Access Compliance Report

Public Rights-of-Way

(Curb Ramps)

Intersection ID: 9612	Main Street: BELLEFONTE_DR	Cross Street: N_PINE_ST	Location: NE
ADA ID: 2492078D3D4E	Ramp Type: Perp	Initial Pass/Fail: Fail	Overall Compliance: No
Severity Score: 10			
Codes/Mitigation Info/Possible Solution		Field Measurements/Component Compliance

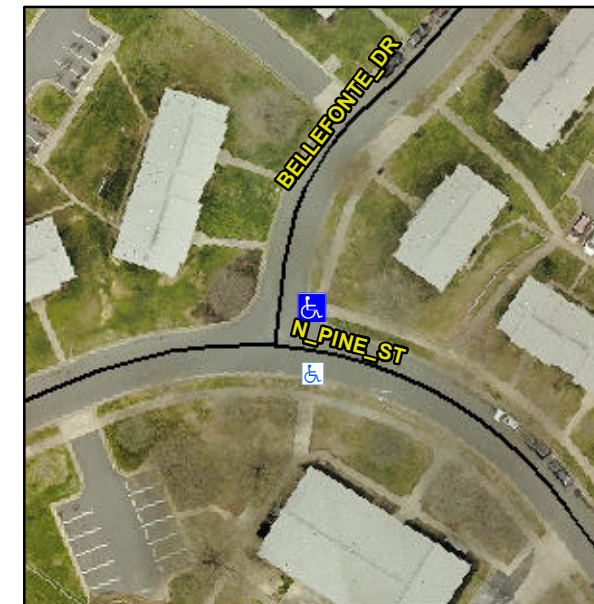
Not Found, R304.5.1, R304.5.3

Compliance	Description	Data	Compliance	Description	Data
N/A	Ramp Length (in)	67.5	Yes	Ramp Slope (%)	6.6
No	Ramp Width (in)	47.5	No	Ramp XSlope (%)	2.6
N/A	Flare Type LT	N/A	N/A	Flare Type RT	N/A
N/A	Flare Slope LT (%)	N/A	N/A	Flare Slope RT (%)	N/A
N/A	Flare Traversable LT?	N/A	N/A	Flare Traversable RT?	N/A
N/A	Landing Length (in)	N/A	N/A	DWS Provided?	N/A
N/A	Landing Width (in)	N/A	N/A	DWS Contrast?	N/A
N/A	Landing Slope (%)	N/A	N/A	DWS Length (in)	N/A
N/A	Landing X Slope (%)	N/A	N/A	DWS Full Width?	N/A
N/A	Landing Curb? (Y/N)	N/A	N/A	DWS Offset (in)	N/A
N/A	Shared Landing?	N/A			
N/A	Gutter Ponding?	N/A	N/A	Gutter Slope (%)	N/A
N/A	Gutter Lip Ht (in)	1.0	N/A	Gutter X Slope (%)	N/A
N/A	Painted X Walk1?	No	N/A	Painted X Walk2?	N/A
	X Walk 1 Direction	To S		X Walk 2 Direction	N/A
N/A	X Walk 1 Width (in)	N/A	N/A	X Walk 2 Width (in)	N/A
	X Walk 1 Slope (%)	1.0		X Walk 2 Slope (%)	N/A
	X Walk 1 X Slope (%)	1.7		X Walk 2 X Slope (%)	N/A

Remove & Replace Entire Ramp.
